#### **Addendum 40 – UN Regulation No. 41**

#### **Revision 2 - Amendment 8**

Supplement 8 to the 04 series of amendments – Date of entry into force: 3 January 2021

#### **Uniform provisions concerning the approval of motor cycles with regard to noise**

Appendix 2, amend to read:

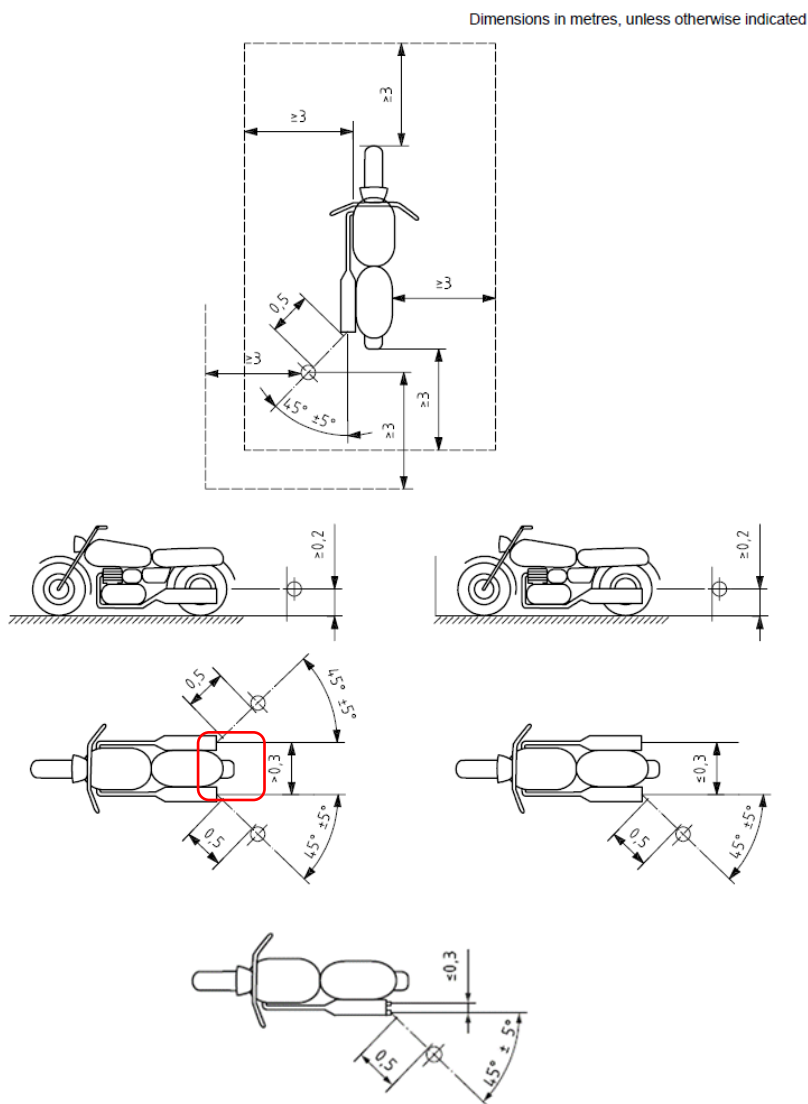
If a vehicle has two or more exhaust outlets spaced less than or equal to 0.3 m apart and connected to a single silencer, only one measurement shall be made. The microphone shall be located relative to the outlet furthest from the vehicle's longitudinal centreline, or, when such outlet does not exist, to the outlet that is highest above the ground. The 0.3 m measurement is to be made along a single plane perpendicular to the flow axis of the exhaust gases.

If a vehicle has two or more exhaust outlets spaced less than or equal to 0.3 m apart and connected to separate silencers, only one measurement shall be made. The microphone shall be located relative to the outlet furthest from the vehicle's longitudinal centreline, or, when such outlet does not exist, to the outlet that is highest above the ground.

For vehicles having an exhaust provided with outlets spaced more than 0.3 m apart, one measurement is made for each outlet as if it were the only one, and

the highest sound pressure level shall be noted. For the purpose of roadside checking, the reference point may be moved to the outer side of the body."

"Positioning of the microphones for the stationary noise test:
